## Remarks

The invention of the present claims is a bushing for receiving a molten material and for fiberizing the molten material, such as molten glass, comprising at least two opposed sidewalls and at least two opposed end walls, a tip plate having at at least 1600 orifices with or without the same number of hollow tips extending from a lower surface, the tip plate being attached to the sidewalls and end walls, the bushing having a boxlike shape having at least four interior corners, an interior support structure welded to a top surface of the tip plate for supporting the tip plate, the support structure forming at least 16 cells located between the bottom of a screen resting on, or mounted very near the top of, the top of the interior support structure. The interior support structure comprises a plurality of intersecting or crossing internal supports with angles between the intersecting supports at each intersection, the internal support structure, in cooperation with the at least one sidewall and the at least one end wall. The screen has a plurality of screen areas containing holes through the screen with a screen area above each of the at least 16 cells fromed by the internal

## Replacement Sheet

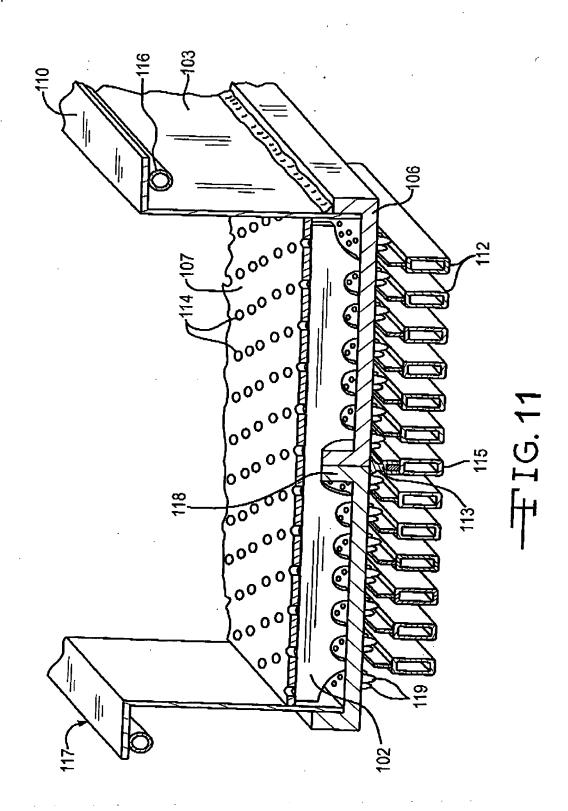
Figure 11 was objected to because the numeral 104 was used to Identify two different items. Proposed replacement Figure 11 attached uses 118 to identify one of the elements objected to and the number 119 to identify the other element objected to. The The Replacement Sheet for Figure 11 was inadvertently not attached to the prior amendment and is attached to this Amendment. Amendment to the appropriate part of the specification correcting the element numbers in accordance with the Replacement Sheet was done in the previous amendment filed Oct. 6, 2006. Applicants believe that Figure 11 is now in compliance with the Rules for drawings and respectfully requests the Examiner to withdraw the objection to the drawings.
